IN THE UNITED STATES PATENT AND TRADEMARK OFFICE

D. RemarksObjections to Drawings

FIG. 3A (BACKGROUND ART)

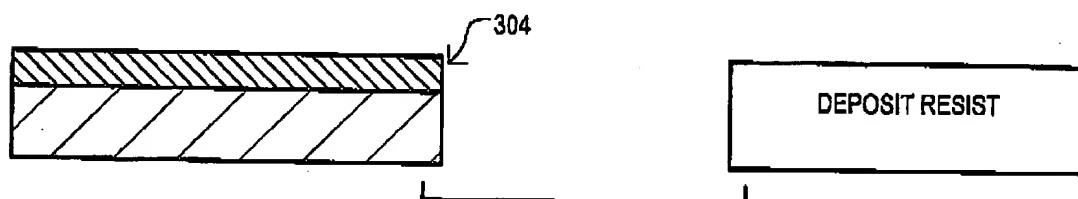
FIGS. 3A to 3E have been amended to address objections to the drawings. Replacement drawings are included herein. The drawings have been amended to include the legend "BACKGROUND ART".
